January 14, 1992  
Project Number 60642

Curragh Resources  
117, Range Road  
Whitehorse, Yukon  
Y1A 2T8

**RE: FURTHER REVIEW OF THE POTENTIAL FOR SEEPAGE FROM THE FARO PIT AND CONTAMINATION OF THE NORTH FORK OF ROSE CREEK**

Figure 1A: Cross-Section through Main Pit to North Fork

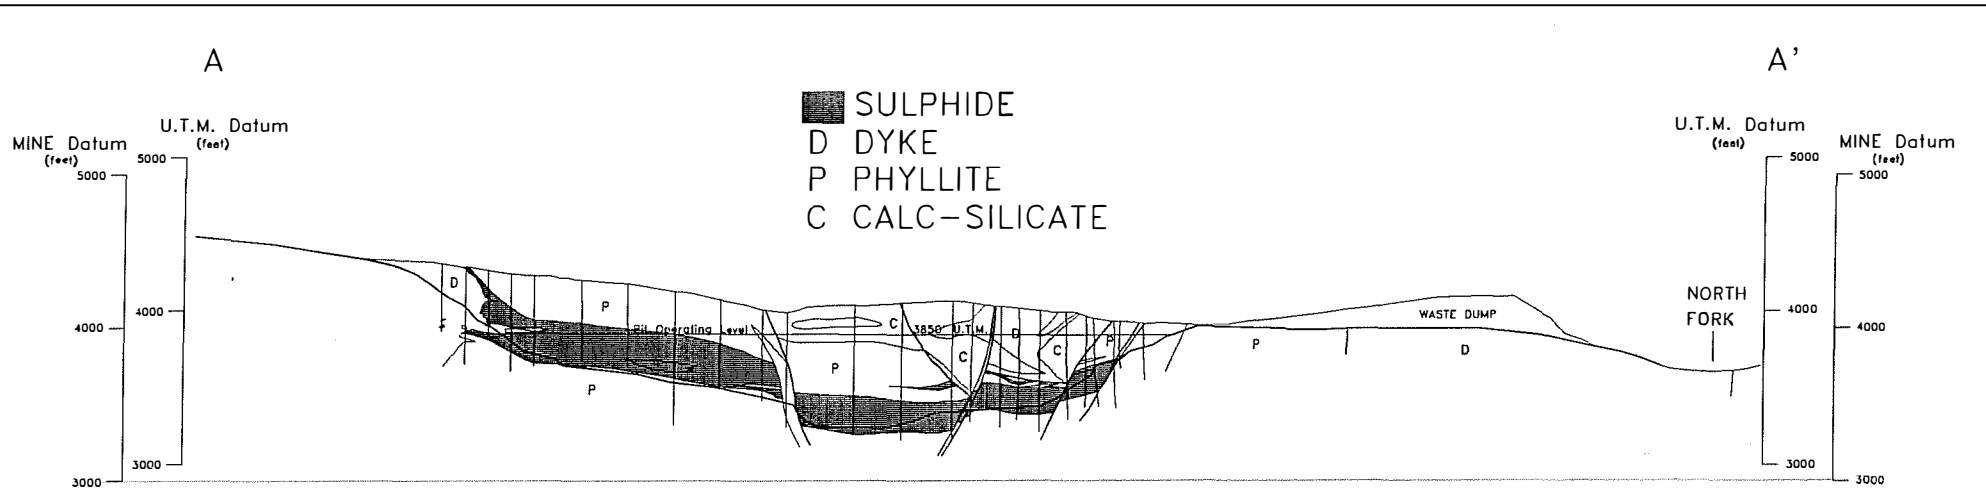
It has been suggested that an extensive investigation program should be undertaken to determine the potential for seepage loss from the Main Pit through the east wall. This is because EP believe there is a risk of poor quality water migration to the North Fork. Potential water quality is addressed below. The nature of the program recommended is similar to the study performed by Piteau and Associates, presented in their report 86-804 of October 1986. The Piteau report has been further reviewed and has been correlated with Curragh's geological data and opinions supplied by Dr Lee Pigage, senior geologist at Curragh. This has enabled a classification of the Faro rock types in terms of their ability to transmit seepage. The rock types are illustrated on geological section A-A' drawn through the Main Pit and extended to the North Fork (see Figure 1A). The locations of the section and the Piteau boreholes are shown on Figure 2.

To put the Main Pit seepage potential into perspective, one can calculate an approximate seepage rate by applying Darcy's Law. If we assume a pit wall dimension of 150 m deep by 300 m long, a hydraulic conductivity of  $1 \times 10^6$  cm/sec, and a relatively high hydraulic gradient of 0.5 (1 is vertical, 0 horizontal), we obtain a seepage rate of  $19 \text{ m}^3/\text{day}$ . For this volume to migrate from the pit to the North Fork, the individual fractures responsible for the permeability must be interconnected and extensive. This seepage estimate should therefore be considered conservative.

Figure 1B: Cross-Section through Zone II Pit to North Fork

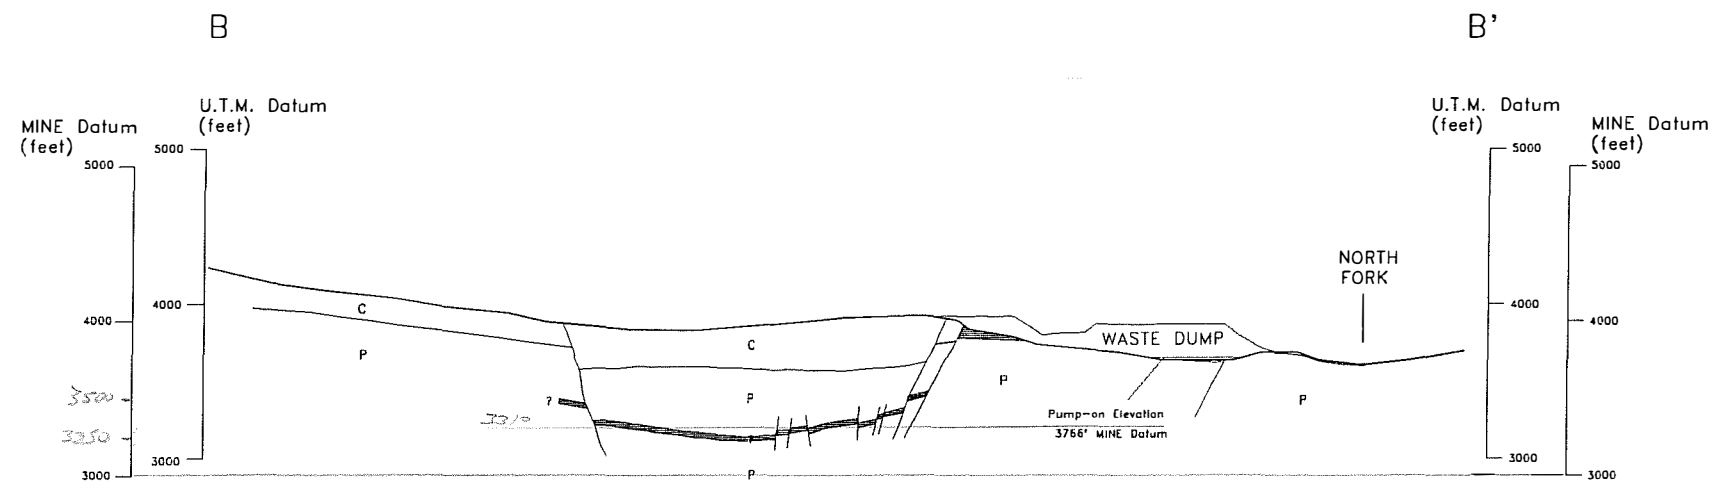
Figure 1B shows geological section B-B' drawn through the pit to the North Fork. The wallrocks on the down-gradient side of the pit are schists or phyllites, and these extend east below the North Fork. Phyllite bedrock was intersected at between 15 - 20 feet in the BH series holes adjacent to the North Fork. These same boreholes recorded groundwater at the base of a silty profile resting on bedrock, with water-levels below the elevation of the adjacent creek. The seepage potential of the schists/phyllites is expected to be low based on the study and interpretation described above. However, the condition of the wallrocks around the rim of the Zone II Pit is not known. Given that the rim is 700 m from the creek, and that the pit is to be used for

contaminated drainage storage, it would be prudent to investigate wallrock conditions and provide monitoring facilities.

Zone II Pit - The wallrocks of the pit require investigation. This will not be an easy task given the waste rock cover which will make borehole location and drilling difficult. Three rotary drilled boreholes should be inserted around the down-gradient rim to a depth of approximately 150 feet, roughly equal to the elevation of the rock surface below the North Fork. The holes should be packer tested and then equipped with two monitoring piezometers each. Hydraulic and water quality data will form the basis for an assessment of seepage potential.

Figure 2  
 Mine topography without  
 waste dumps  
 (Mine Datum)

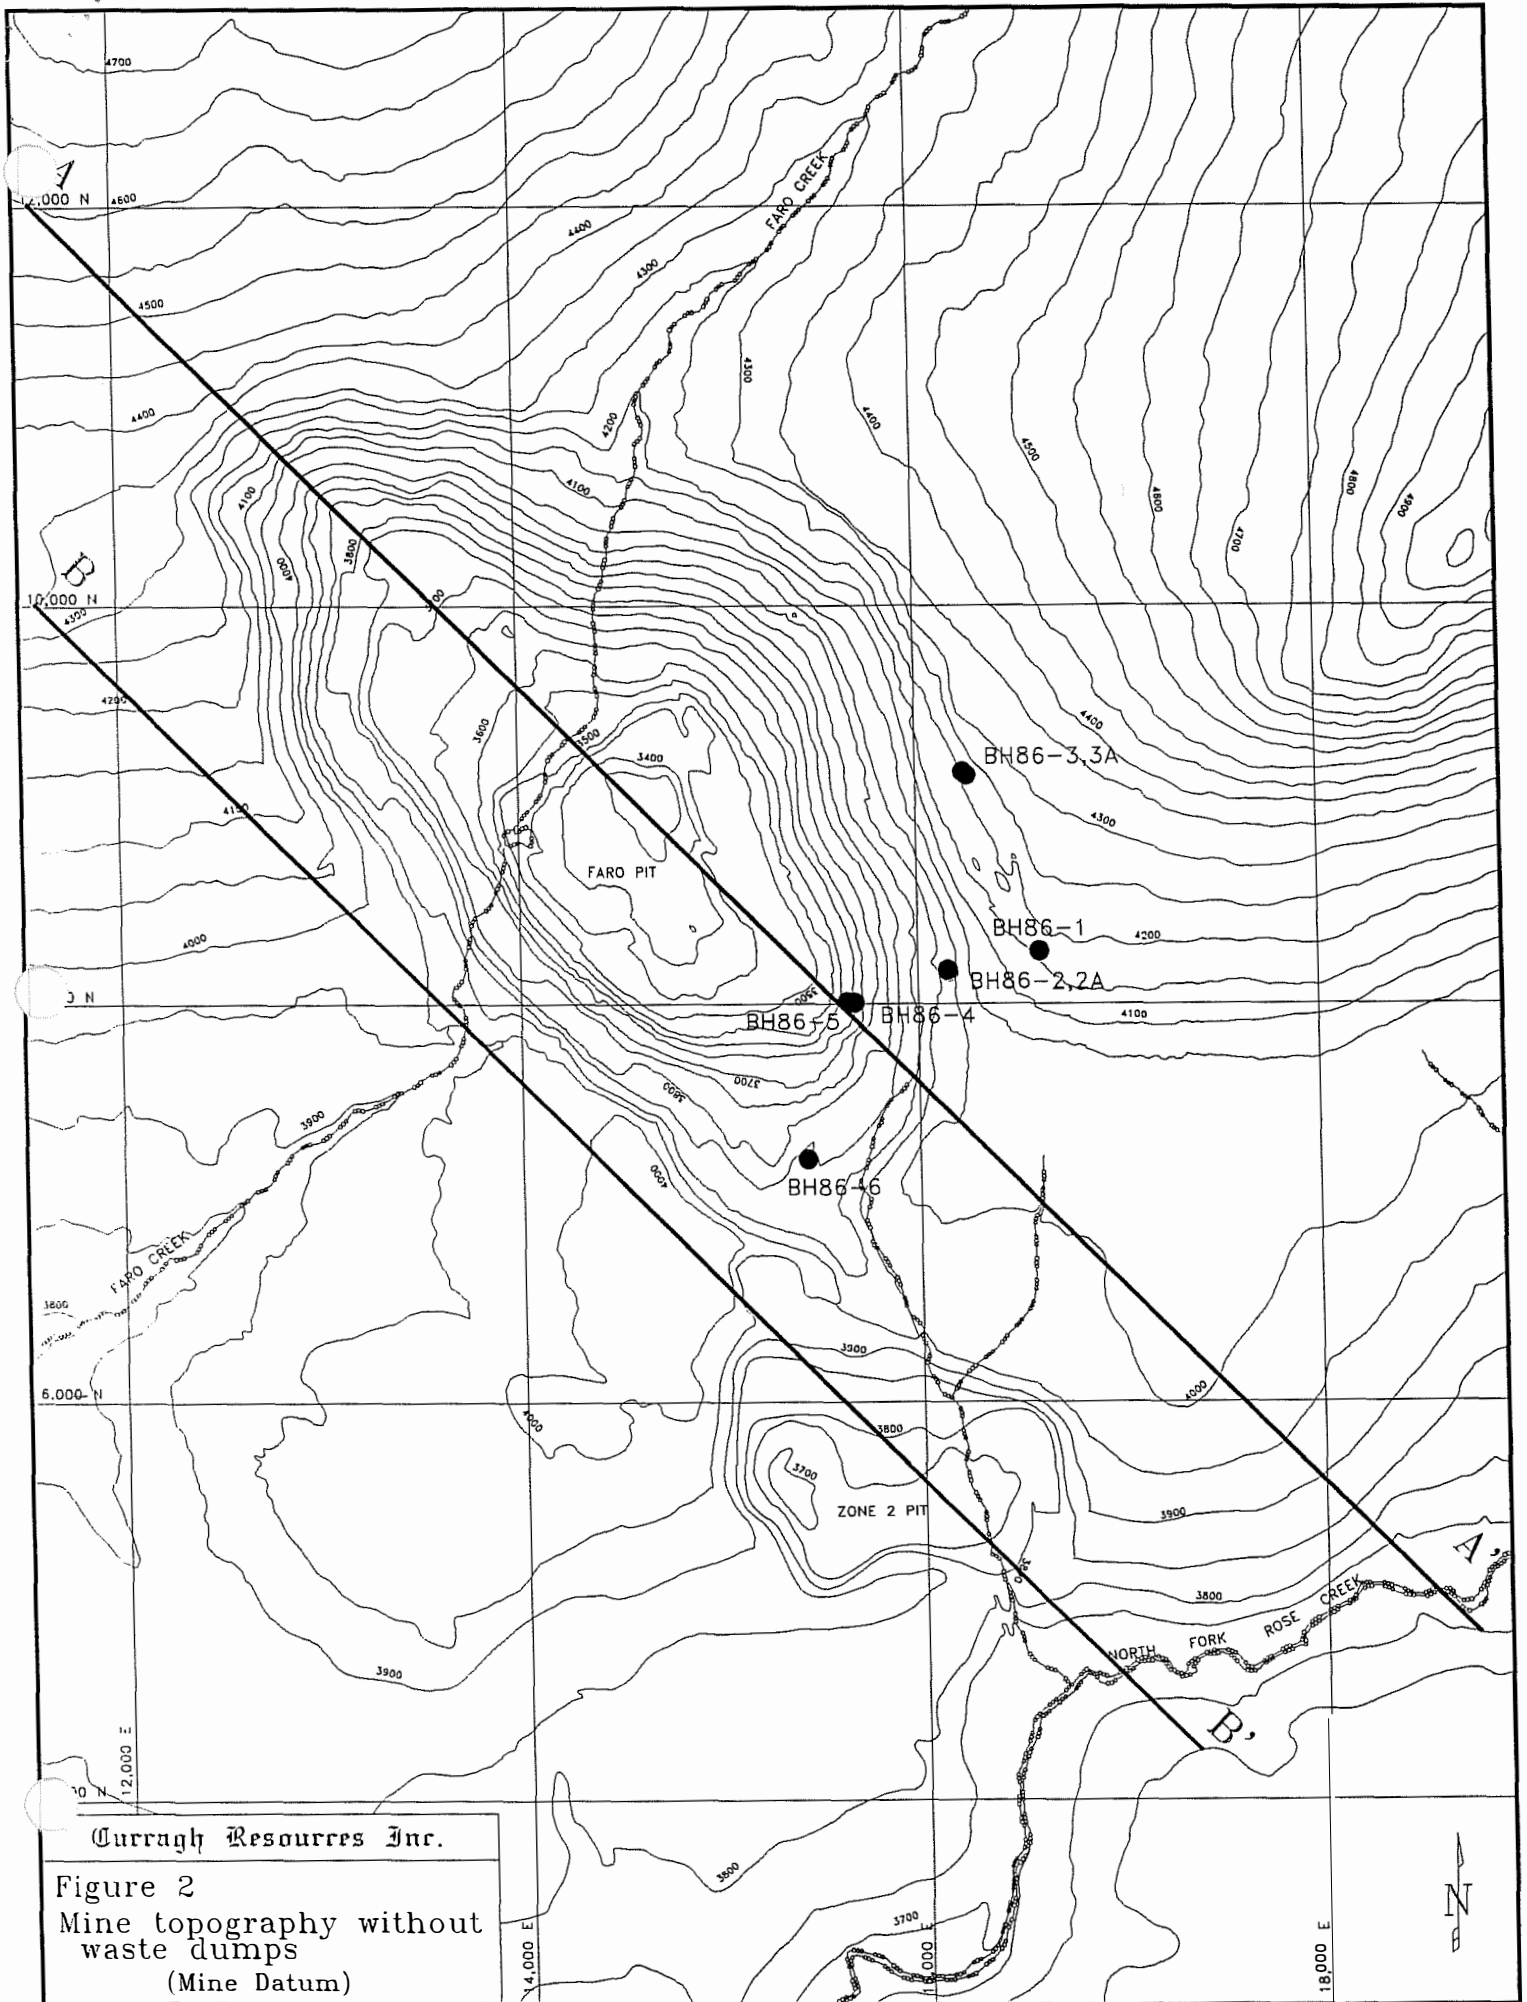
Waste rock dumps line the western side of the North Fork valley, which includes the filling of the Zone II Pit. Figure 2 shows the natural topography below the waste rock. Precipitation is infiltrating through these dumps, and has the potential for leaching soluble salts. Once this infiltration reaches the base of the dumps, part will infiltrate into the natural soils, and part will run-off through the dump and probably flow onto and infiltrate into the alluvial silty sediments of the North Fork valley. This is probably significant to the north of the Zone II Pit, although the waste rock deposited over the rim of the pit also has potential for contributing run-off. The unit mean annual run-off calculated for the Faro site is 260 mm (SRK report 60635). An estimate of infiltration through the North Fork dumps and subsequent run-off can be made by assuming a dump area of 360,000m<sup>2</sup>, and infiltration rate of 150 mm. This derives a flow of approximately 150 m<sup>3</sup>/day, greater than an order of magnitude larger than the Main Pit seepage estimate. The water quality of this flow is not easily estimated. Visible seeps have not been recorded at the toe of the dumps. However, the seepage is probably migrating into the valley sediments just below the surface. A shallow groundwater survey conducted by Curragh personnel in 1990 in the valley area provided a number of water samples. These had sulphate concentrations indicative of neutralized acid drainage (up to between 1200 and 2250 mg/L), although metal concentrations were low with an average zinc concentration of 0.07 mg/L, and a peak of 0.4 mg/L.
